**Landscape Review Committee
ZOOM Online Meeting
August 19, 2020 - 12:00 PM**

DATE: August 19, 2020
TO: Landscape Review Committee Members
FROM: Jamie Fleckenstein, Associate Planner
SUBJECT: Agenda Item 4A – Landscape Plan Review Application (L 24-20)

**DECISION, CONDITIONS, FINDINGS OF FACT AND CONCLUSIONARY FINDINGS FOR THE
APPROVAL OF A LANDSCAPE PLAN REVIEW FOR BAKER CREEK SUBSTATION AT 1901 NW
BAKER CREEK ROAD**

DOCKET: L 24-20 (Landscape Plan Review)

Figure 5: Proposed Landscape Plan

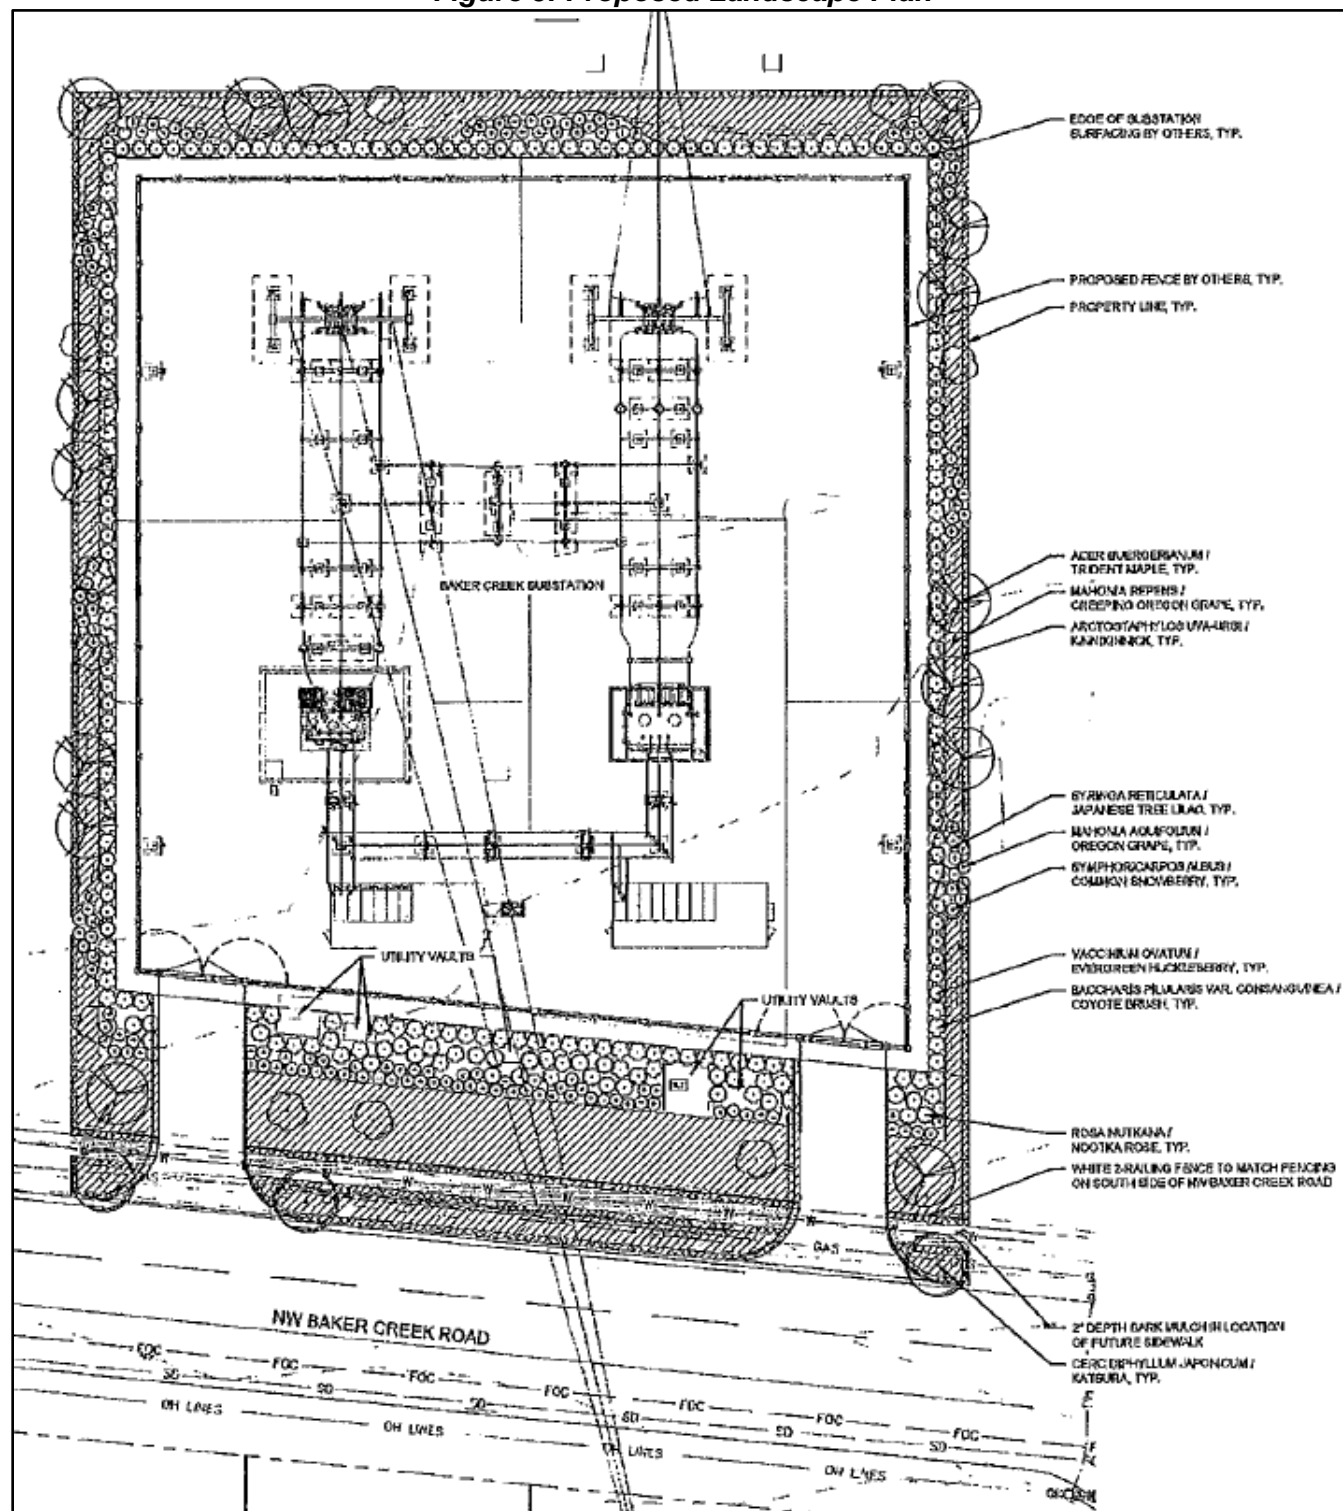
1. Staff would recommend approving this proposal.
 - The submitted landscaping plan shows 3 street trees adjacent to Baker Creek in the public right of way. Given the overhead power conflicts, staff concurs with the spacing as proposed.

- The plan proposes Katsura trees as a street tree. Katsura is a proven street tree, and is listed in the McMinnville Street Tree List.
 - The remainder of landscaping in the right of way appears to be groundcover, which is consistent with the site conditions, as well as with the overall approach to this proposal.

- The remainder of the plantings are outside of the public right of way, and are thus out of our purview.
 - The applicant should be reminded that the tree plantings adjacent to the driveway access onto Baker Creek Road should be planted no closer than 5' from the private drive, and planted and maintained in such a manner as to maintain vision clearance for vehicles exiting the site.

1. That the applicant shall install landscaping as shown on the landscape plans received by the Planning Department on July 17, 2020 and shall comply with required conditions of approval.
2. That the applicant contact the appropriate utility-locate service (dial 811 or 800-332-2344) prior to any planting excavation to ensure that underground utilities are not damaged.
3. That the applicant is reminded that trees are not to be planted within:
 - a. Five (5) feet of a private driveway or alley;

Figure 4: Proposed Landscape Plan

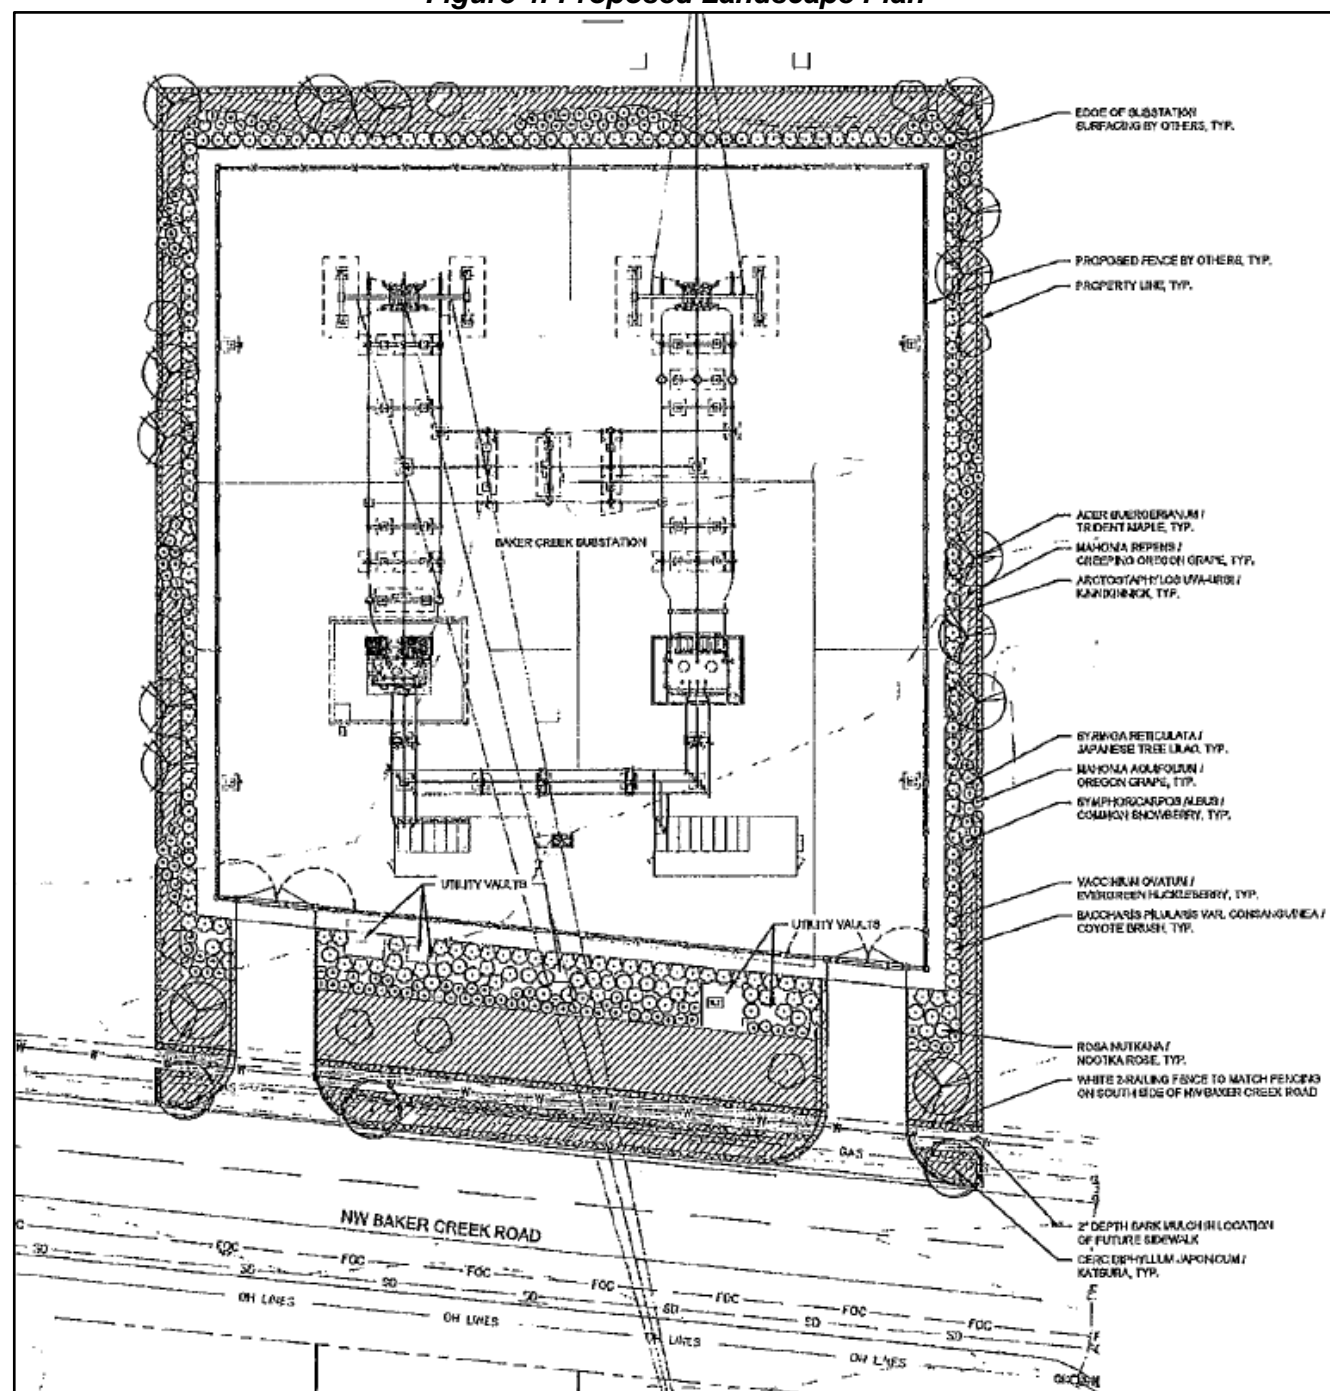
1. Staff would recommend approving this proposal.
 - The submitted landscaping plan shows 3 street trees adjacent to Baker Creek in the public right of way. Given the overhead power conflicts staff concurs with the spacing as proposed.

- The plan proposes Katsura trees as a street tree. Katsura is a proven street tree, and is listed in the McMinnville Street Tree List.
 - The remainder of landscaping in the right of way appears to be groundcover, which is consistent with the site conditions, as well as with the overall approach to this proposal.

- The remainder of the plantings are outside of the public right of way, and are thus out of our purview.
 - The applicant should be reminded that the tree plantings adjacent to the driveway access onto Baker Creek Road should be planted no closer than 5' from the private drive, and planted and maintained in such a manner as to maintain vision clearance for vehicles exiting the site.

1. That the applicant shall install landscaping as shown on the landscape plans received by the Planning Department on July 17, 2020 and shall comply with required conditions of approval.

3. That the applicant is reminded that trees are not to be planted within:
 - a. Five (5) feet of a private driveway or alley;
 - b. Ten (10) feet of a fire hydrant, transformer, power or water vault, water meter box, utility pole, sanitary sewer, storm or water line; or

- c. Twenty (20) feet of street light standards or street intersections.
4. That the applicant shall maintain proper clearances around the existing and future water and electrical services that will be located on the site. Landscaping shall not be placed within four (4) feet of fire hydrants, within four (4) feet of water valves, within four (4) feet of vaults, within three (3) feet of the back or side of a transformer, or within one (1) foot of water meters. Minor adjustments in plant placement from the locations shown on the approved landscape plan are allowed if relocation is necessary to meet minimum clearances.

Proposed Landscaping Along East Property Line

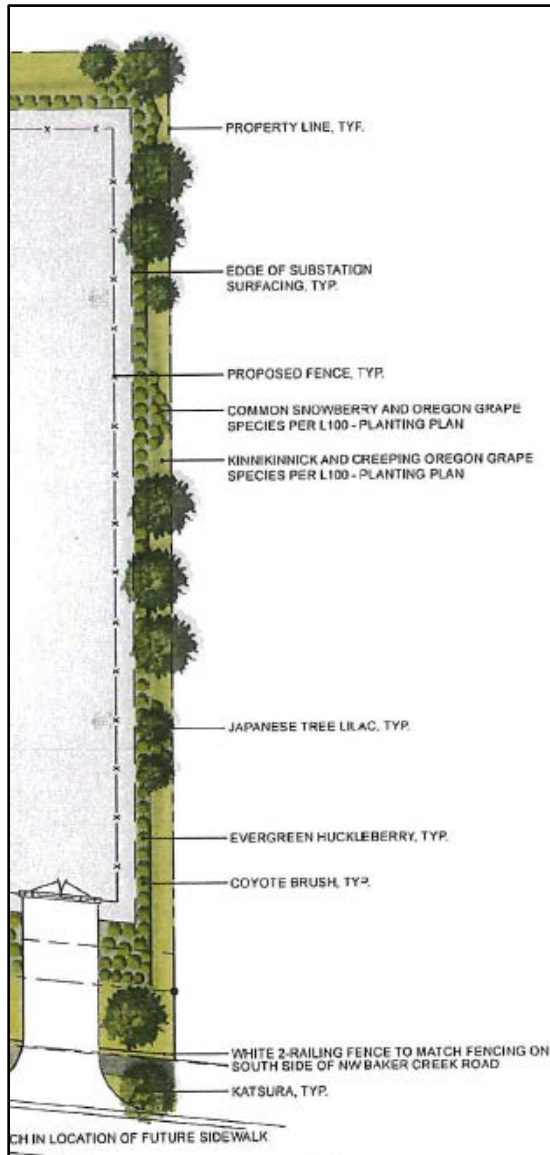
The east side of the substation property is adjacent to the extension of the Westside Pedestrian/Bicycle Trail along the northerly extension of Meadows Drive through BCN. Along Meadows Drive in BCN, October Glory Red Maples are planted as street trees, and lawn is proposed in the narrow strip between the trail and the east edge of the substation site. Landscaping proposed along the eastern property line includes trees, shrubs, and groundcover that will provide screening, interest, and shade. Proposed trees include the Trident Maple and the the Japanese Tree Lilac. The Japanese Tree Lilac is an approved street tree along Meadows Drive in BCN, and the use of the tree at the substation will provide consistency and continuity between the properties.

Shrubs that are proposed close to the fenceline include the large evergreens *Vaccinium ovatum* (Evergreen Huckleberry), *Baccharis pilularis* var. *consanguinea* (Coyote Brush), and Tall Oregon Grape, as well as the the smaller deciduous shrub Common Snowberry. The spreading evergreen groundcovers Creeping Oregon Grape and Kinnickinick provide transition from the taller shrub planting to the lawn area adjacent to the Westside Pedestrian/Bicycle Trail. The shrubs and groundcovers are all native species and are considered drought-tolerant following establishment.

Proposed Landscaping Along North and West Property Lines

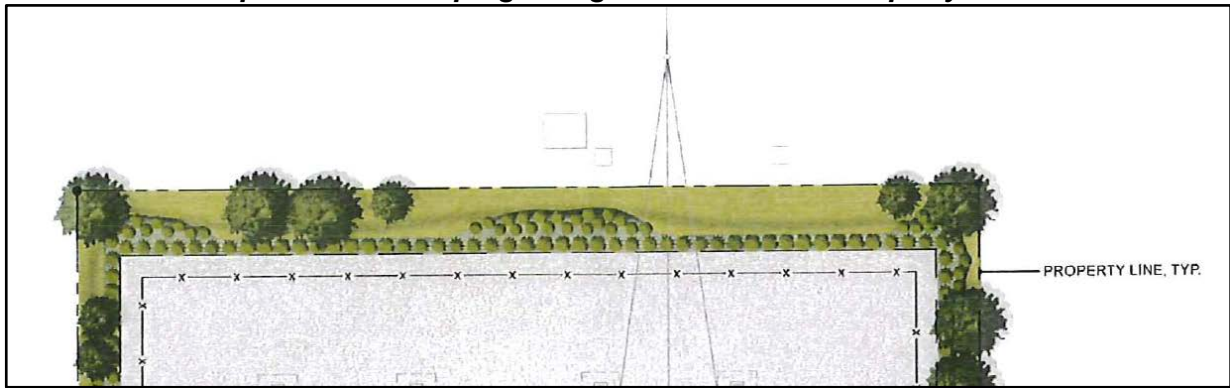
The proposed planting around the north and west sides of the substation property continue the planting style and theme established on the east side. Groupings of the large evergreen shrubs Evergreen Huckleberry, Coyote Brush, and Tall Oregon Grape, as well as the the smaller deciduous shrub Common Snowberry are planted along the fenceline to provide screening and interest. Trident Maple and Japanese Tree Lilac trees are also proposed along the perimeter and will provide screening and shade. Trees are spaced away from the electric transmission lines heading north from the substation to avoid future conflicts. The spreading evergreen groundcovers Creeping Oregon Grape and Kinnickinick provide transition from the taller shrub planting to the adjacent property to the north and west.

Northeast of the substation is Open Space Tract 'J' of Baker Creek North. The approved design of Tract J includes an open lawn area with a picnic table and a bench along the trail. Evergreen trees near the substation will provide some separation and screening of the substation. The siting of the Trident Maple and Japanese Tree Lilac in the northeast corner of the subject property will help provide further screening and buffering of the substation from the adjacent open space Tract J.

Northwest and west of the substation site is undeveloped commercially zoned land. The proposed planting will help provide screening and buffering of the substation from the commercial property when it is developed.

Overall the style and characteristics of the proposed landscaping is compatible with the project and the adjacent surrounding properties. Trees are appropriately sized and spaced to avoid conflicts with overhead transmission wires and the substation equipment inside the fencing. Plantings around the perimeter include drought-tolerant native species that will help screen and buffer the substation from surrounding uses. The continuation of white rail fencing along Baker Creek Road and the use of Japanese Tree Lilacs help to provide consistency and continuity between surrounding properties and uses. Overall, staff finds the landscape plan is compatible with the proposed project and surrounding properties and uses.
